**City of Bellevue  
Development Services Department  
Land Use Staff Report**

**Proposal Name:** Segireddy Residence

**Proposal Description:** Land Use review of a proposal to reduce a steep slope critical area toe-of-slope structure setback from 75 feet to 5 feet and remove 2 trees in the critical area in order to construct a new single-family residence and associated improvements.

**File Number:** 23-125870-LO

Figure 1

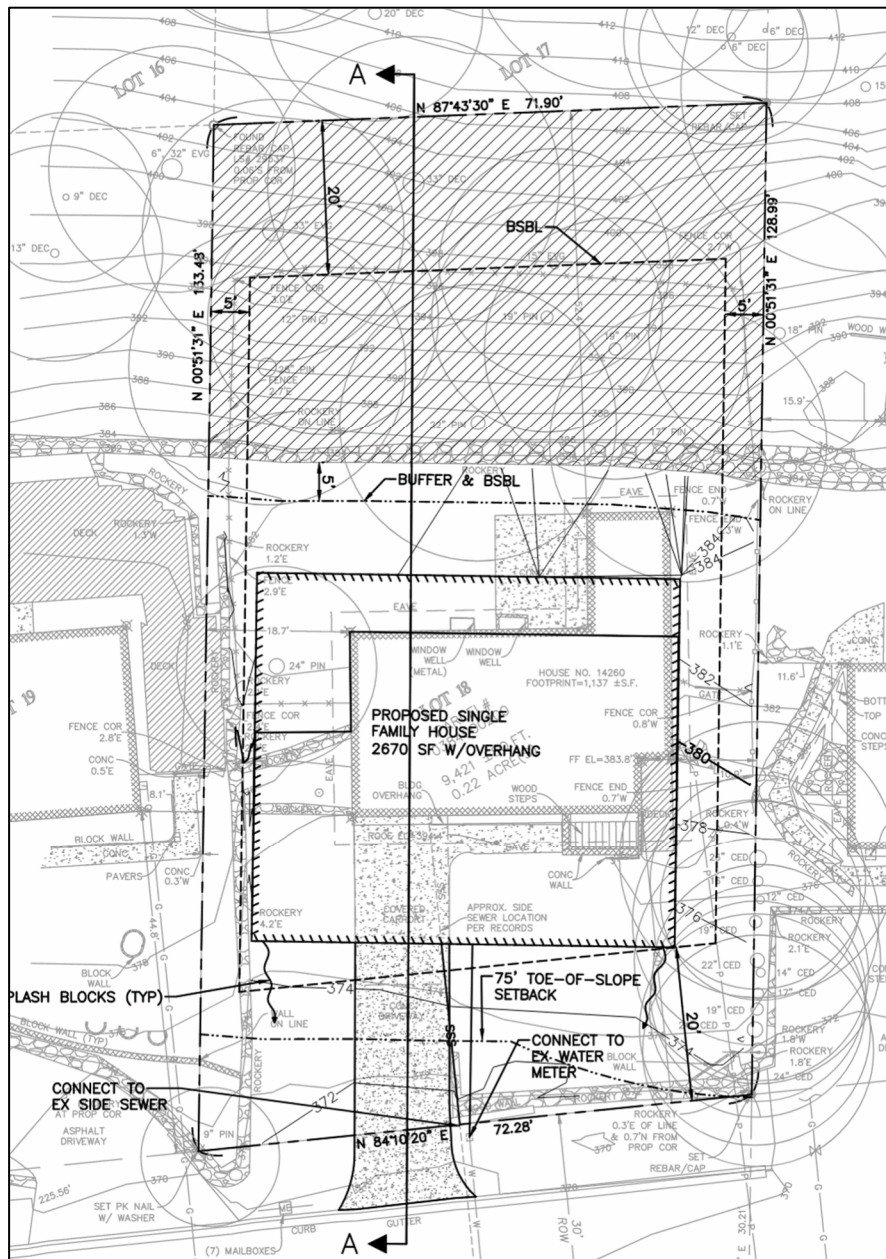
The applicant proposes to construct a single-family residence on a property that has steep slope critical areas. In order to avoid the slopes and buffers the house is proposed to be located in a 75-foot toe-of-slope setback. A geotechnical engineer has reviewed the proposed setback reduction of 75 feet to 5 feet and found the reduced setback provides adequate protection. The proposal will remove 2 hazardous trees within the steep slope and one tree within the steep slope structure setback. As mitigation, the proposal will remove 1,571 square feet of invasive species within the steep slope and replant the area with native vegetation including 4 trees. A Critical Area Land Use Permit is required to approve modification of the toe-of-slope setback. See Figure 1 below for a site plan.

SITE PLAN B AND MITIGATION PLAN  
 SEGREDDY RESIDENCE  
 14260 SE ALLEN RD, BELLEVUE, WA 98006 (BELLEVUE)

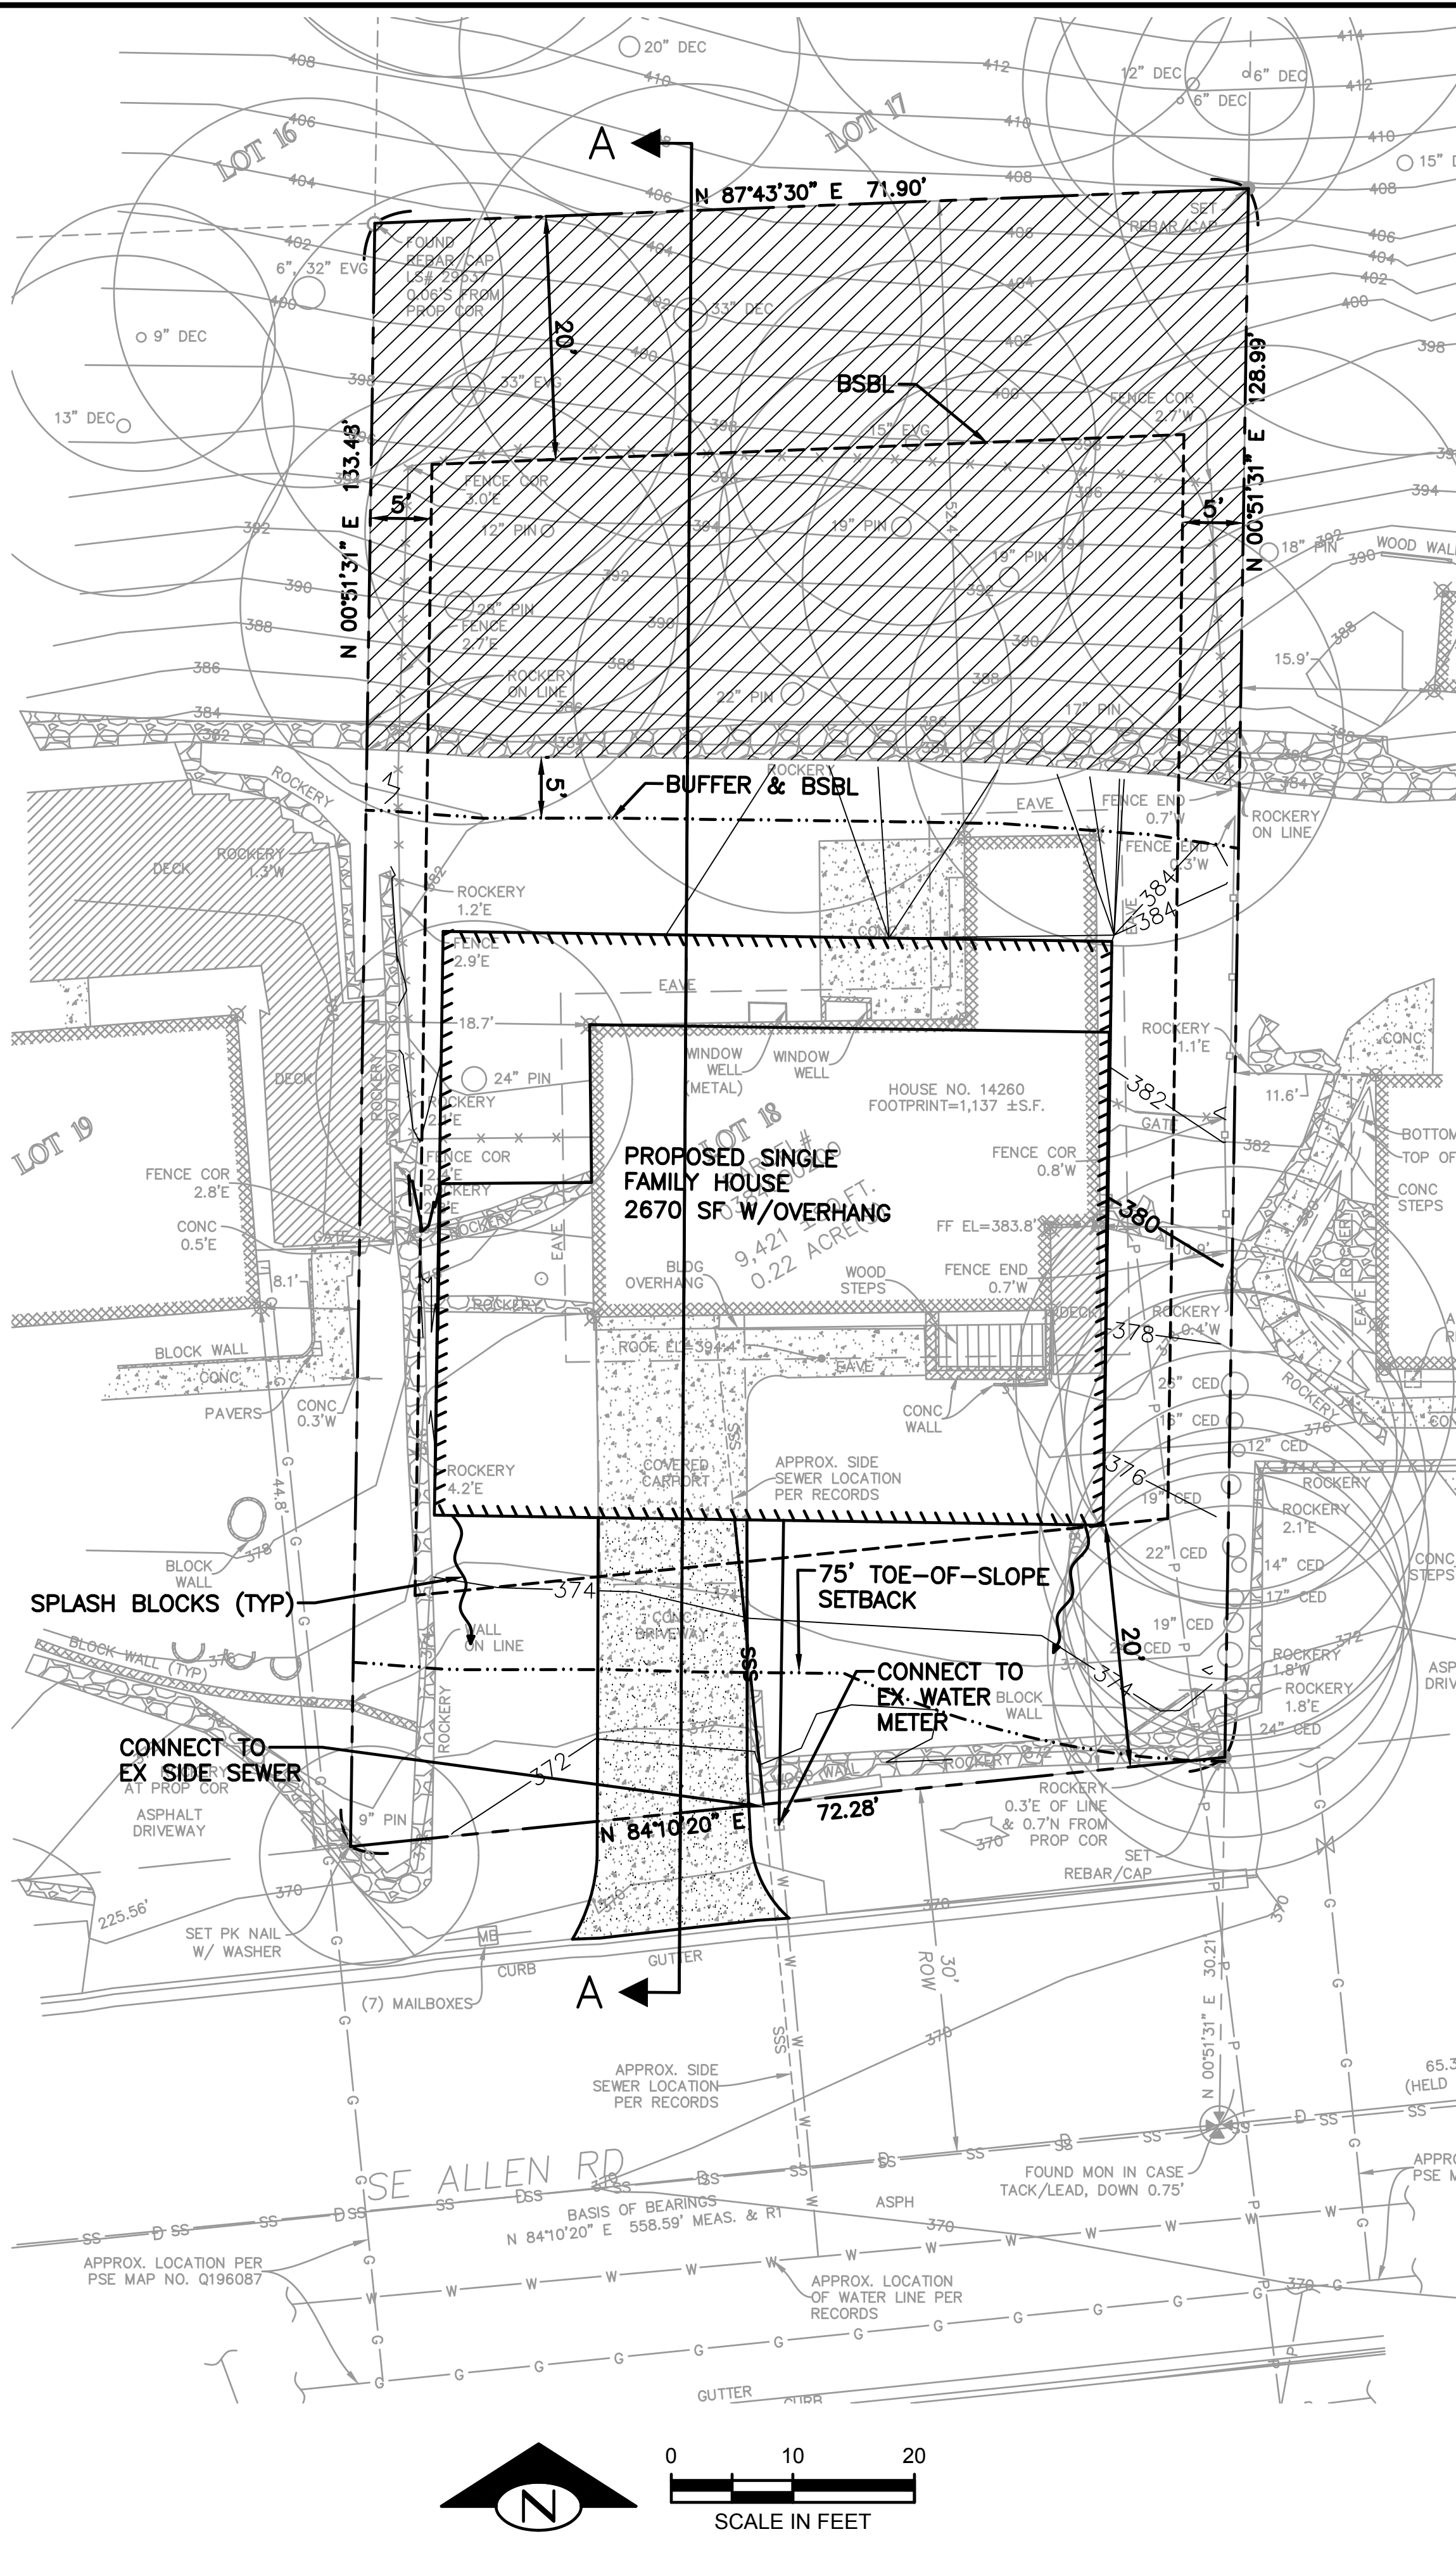
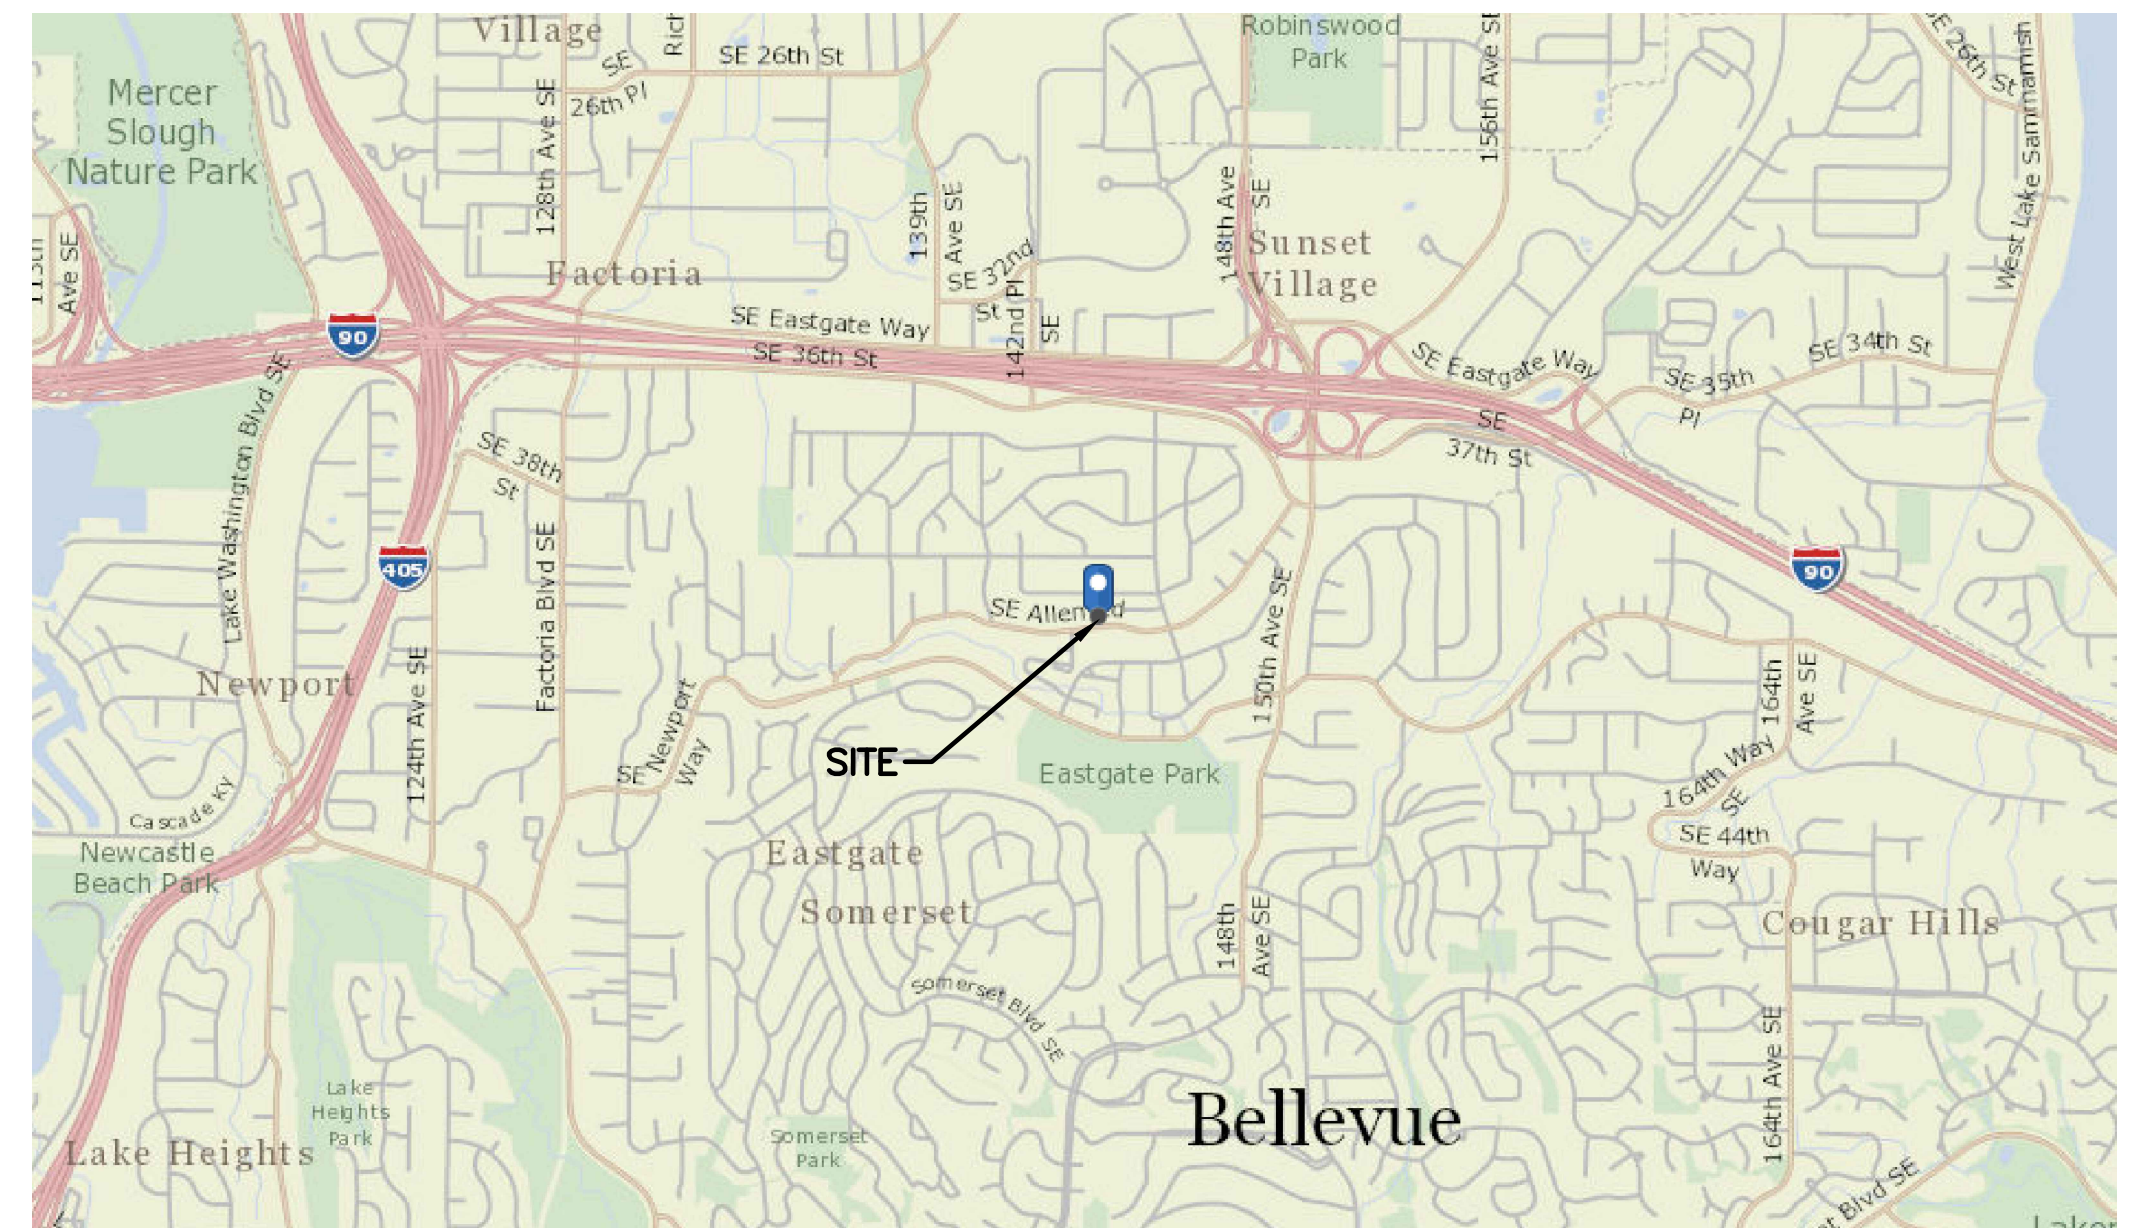
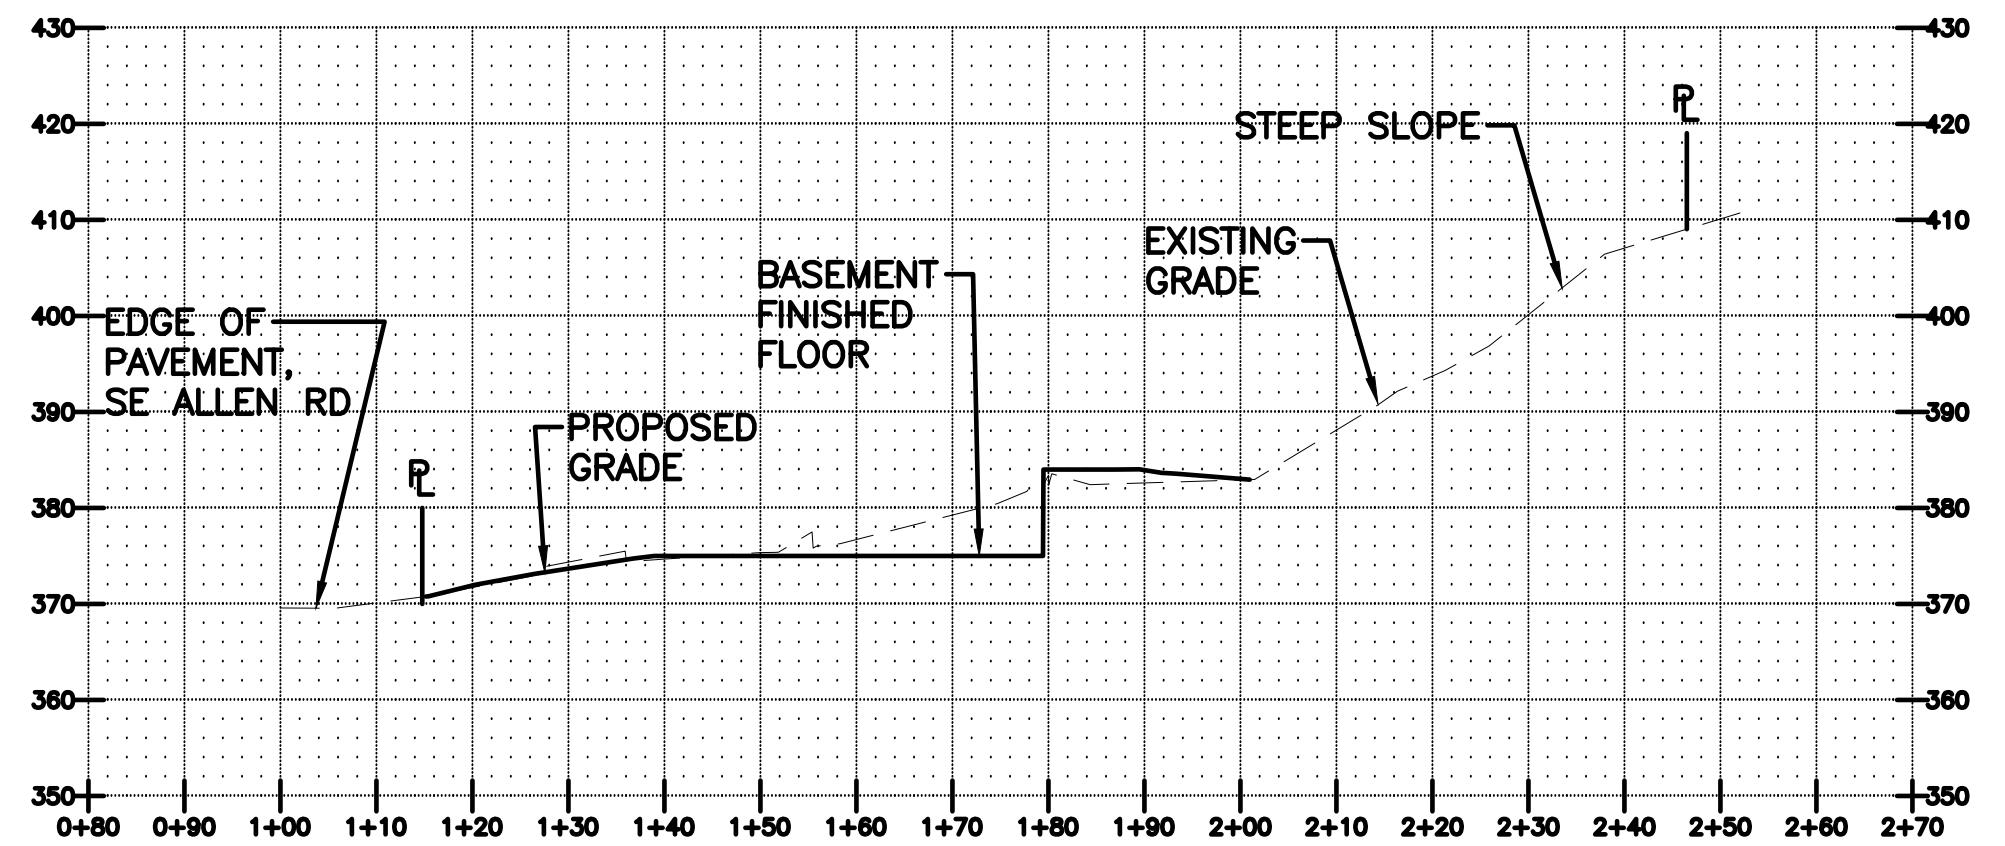
1. THIS PROJECT PROPOSES TO REDUCE THE TOE-OF-SLOPE SETBACK FROM 75' TO 5', BASED ON THE ANALYSIS IN P.3 OF THE GEOTECHNICAL REPORT.
2. PROPOSED SLOPE MITIGATION WILL INCLUDE REMOVING INVASIVE SPECIES AND REPLANTING WITH NATIVE NON-INVASIVE VEGETATION. SEE THE CRITICAL AREAS REPORT AND MITIGATION PLAN.

- 2. Mitigation Planting:** Plans submitted for the building permit must show the proposed planting of four (4) trees and other mitigation planting as described in this report.
